# CITY OF ALBUQUERQUE

Planning Department  
Alan Varela, Director

**Re: Olive Garden**  
**3823 Coors Blvd. NW**  
**Traffic Circulation Layout**  
Engineer's/Architect's Stamp 8-19-24 (G11D067F)

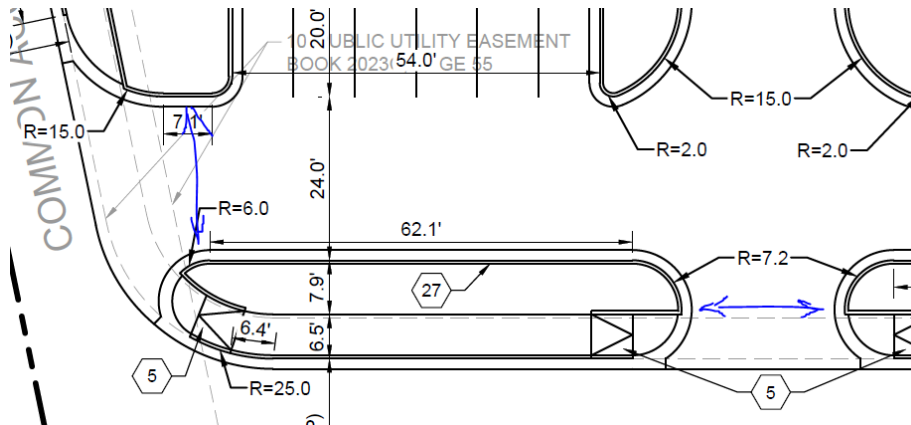
1. Based on 7900 SF Restaurant, you need 44 parking spaces (5.6 per 1000 SF) not 64

2. Clarify the extents of the current phase. Provide a phasing plan. The overflow parking is not included in this phase, please remove it from the table above
3. Identify the right of way width, medians, curb cuts, and street widths on Coors.
4. Show the dimensions of the entrances and directions of travel
